**Subject: Cell 1 and Landfill Site Certification Addendum  
Enterprise Recycling & Disposal Facility  
Angelo's Aggregate Materials, Ltd.  
FDEP Permit Nos. 177982-001-SC, 177982-002-SO  
Pasco County, Florida**

Hartman and Associates, Inc. (HAI) is writing on behalf of Angelo's Aggregate Materials Ltd. (Angelo's), in response to preliminary review comments provided by the Department to Craig Bryan during a telephone conversation on October 22, 2003 regarding the above-referenced Certification application dated October 8, 2003. For your convenience, we have provided your comments (in bold typeface) for each of our responses.

ASBUILT SURVEY  
WEST BERM CELL 1  
ENTERPRISE RD RECYCLING CENTER

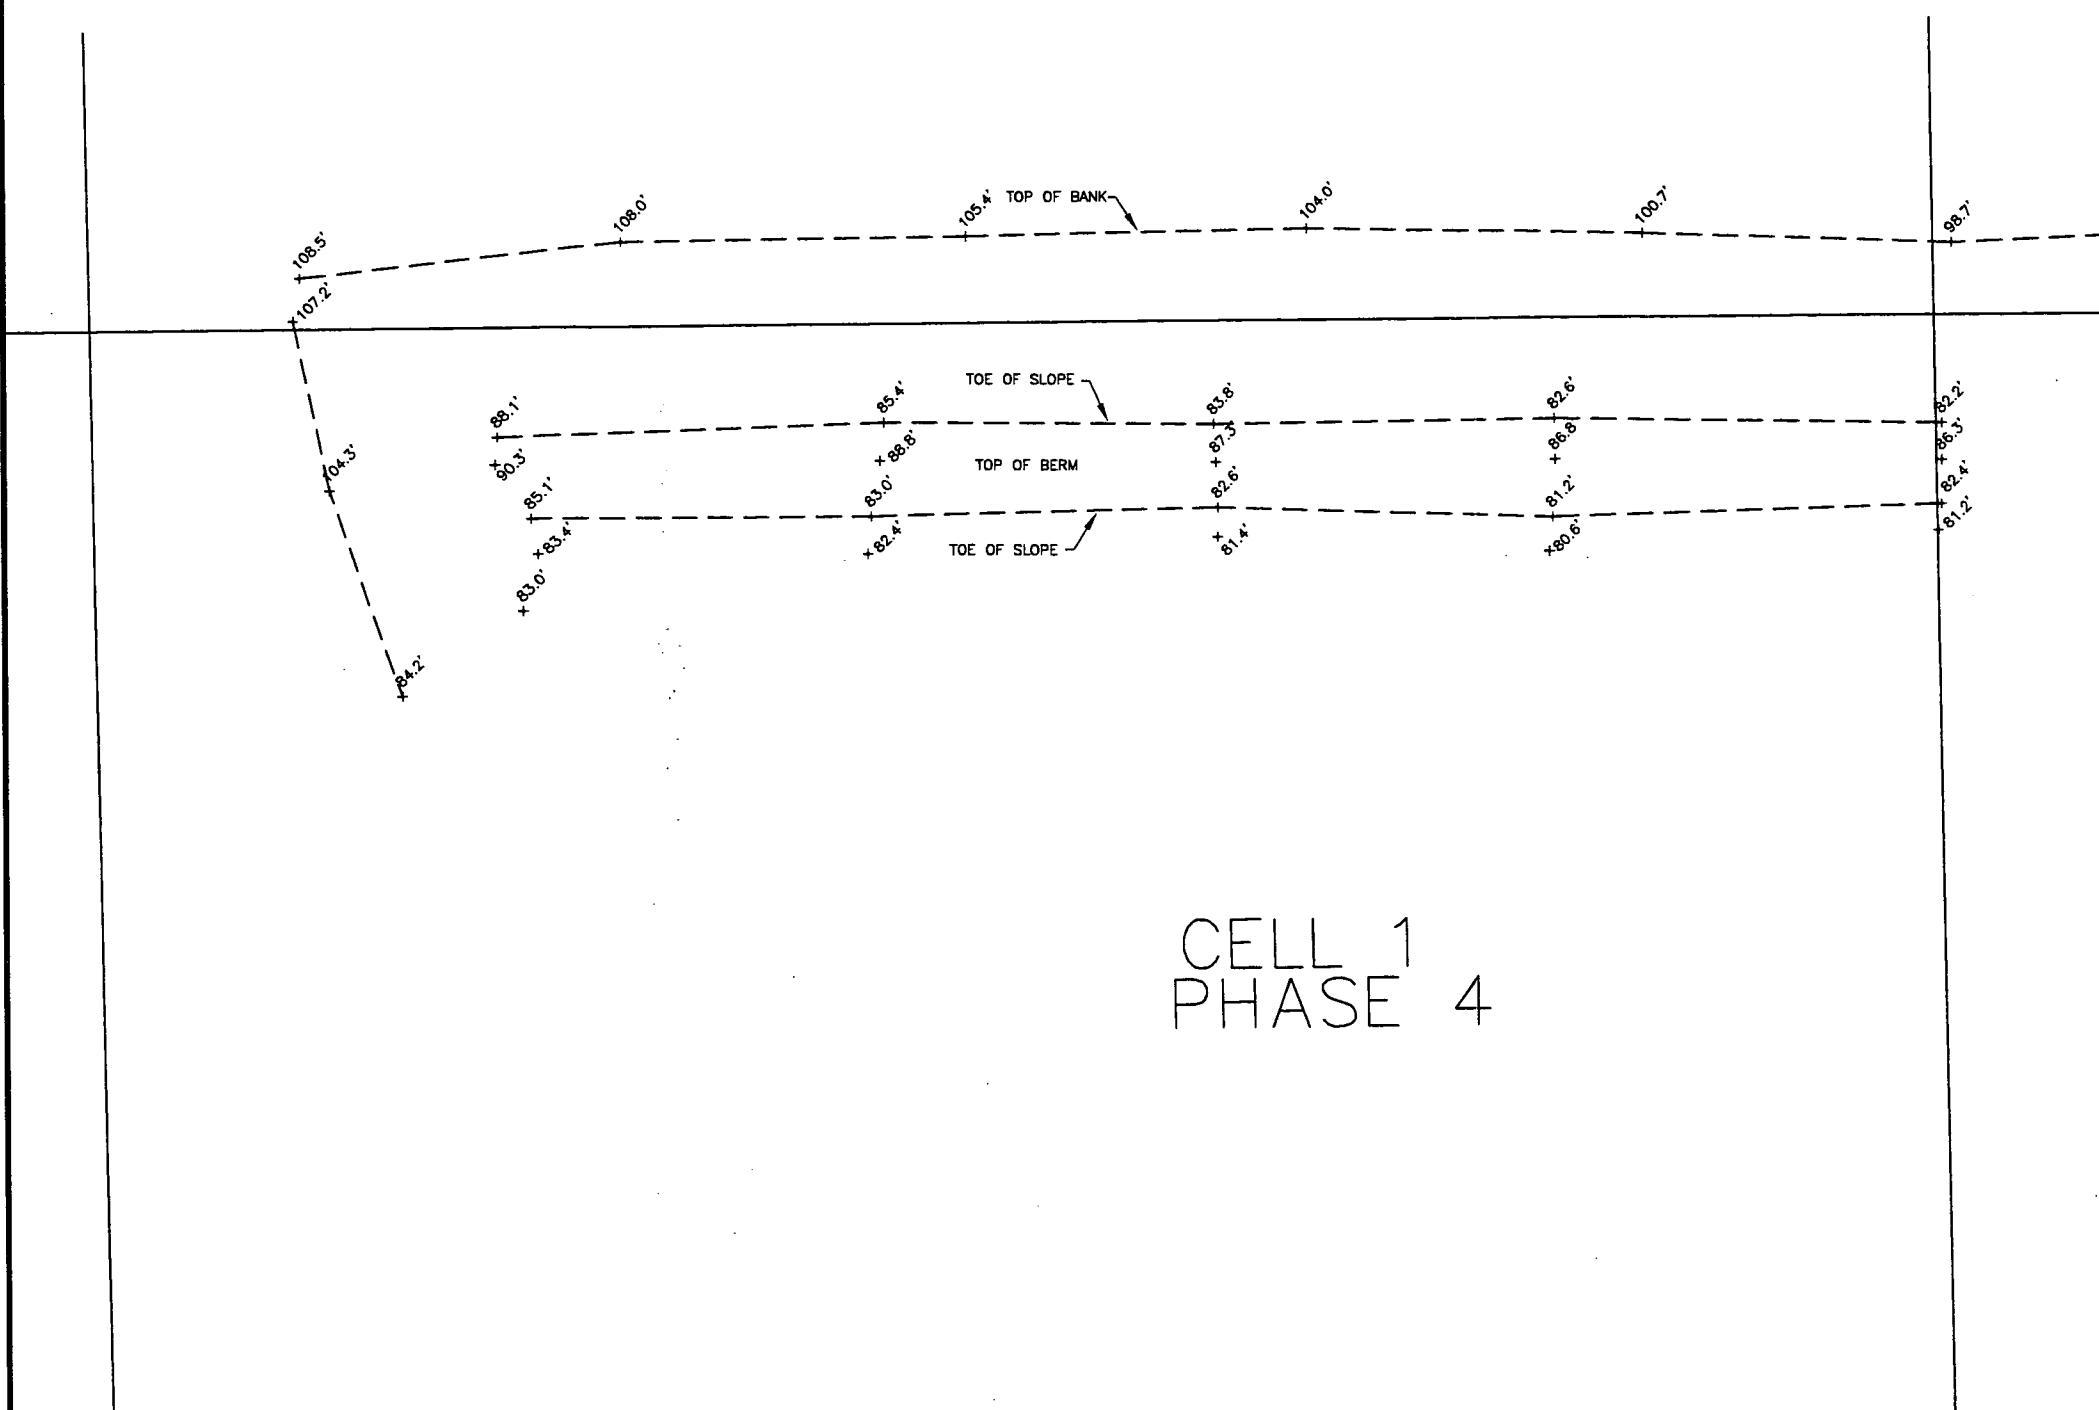
The original certification also discussed several items that were in need of completion before the site could be fully certified for operation. The following describes these items and how they have been or will be addressed prior to operation.

A swale was to be designed and constructed in the west portion of Cell 1 to convey stormwater to the temporary pond and away from waste. This swale has been constructed and was approved by HAI's civil engineering department. A survey of the swale, provided by Foresight Surveyors, is included in Appendix C.
